Mobile Intel® Pentium® 4 Processor-M and Intel® 852PM/GME/GMV Chipset Platform

Design Guide Update

April 2005

1. **Correction on Pinout/Connection for Processor Power**

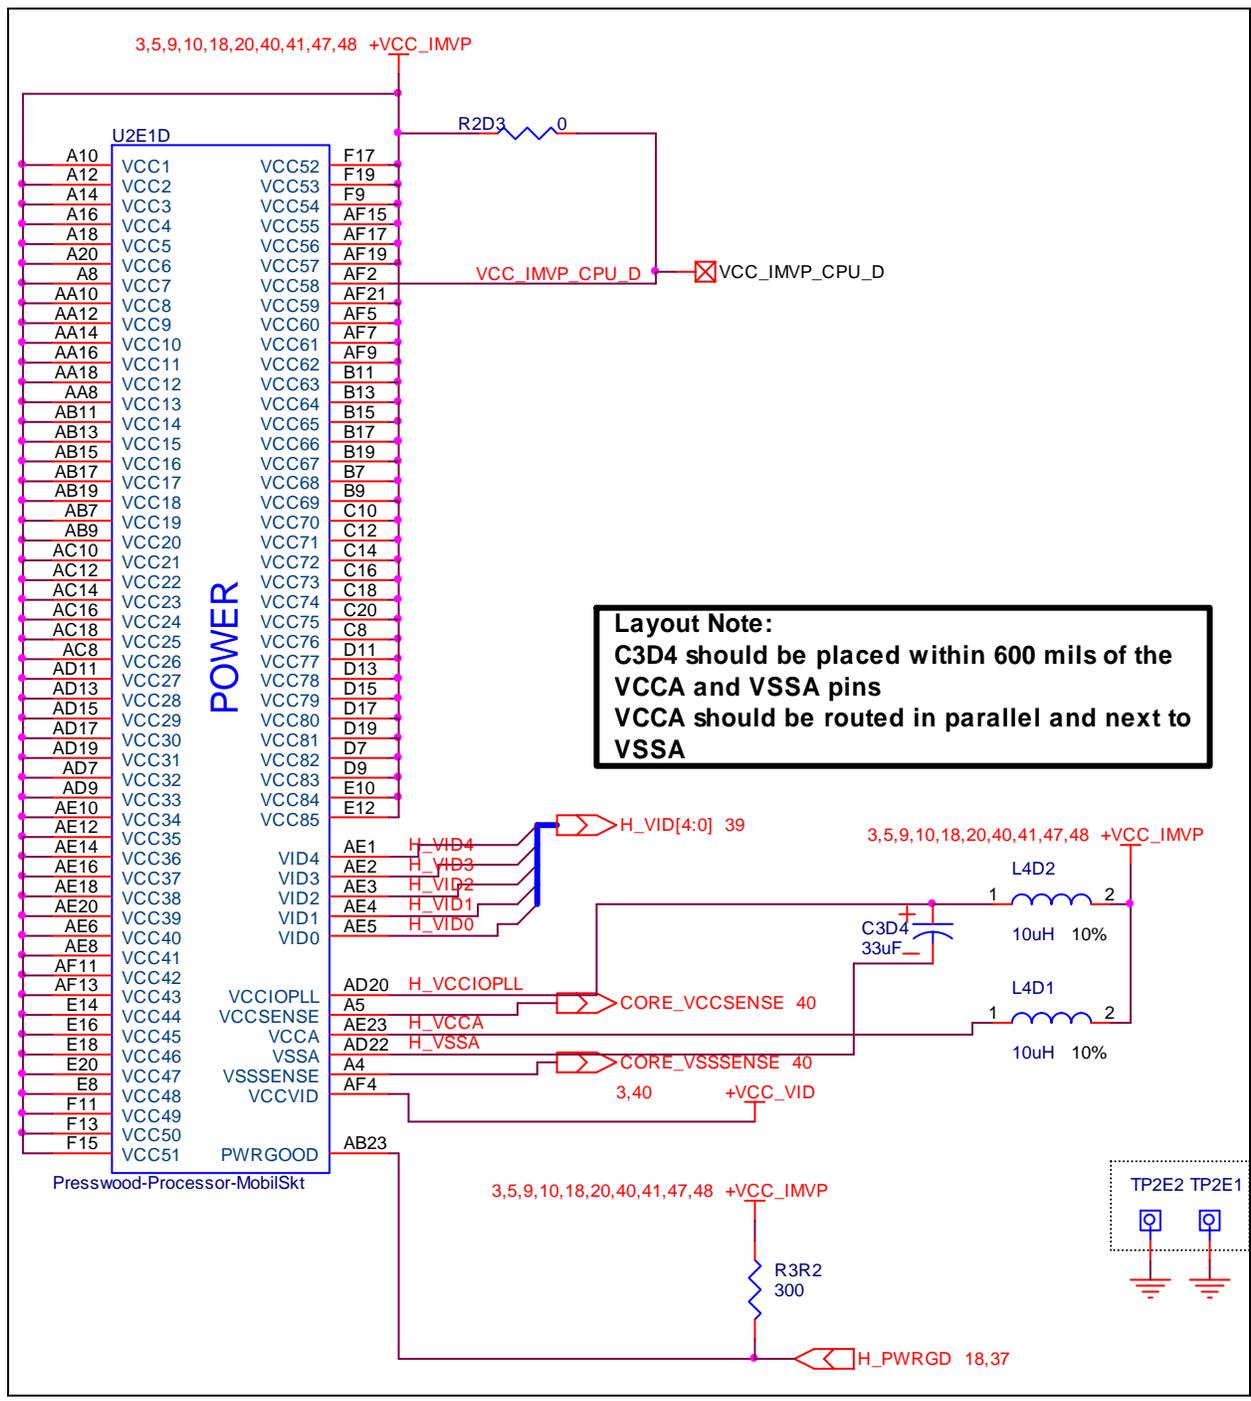
Schematics net connections for VCCA and VCCIOPLL for the processor power should be corrected as follows (schematics sheet 4).

Layout Note:
C3D4 should be placed within 600 mils of the VCCA and VSSA pins
VCCA should be routed in parallel and next to VSSA
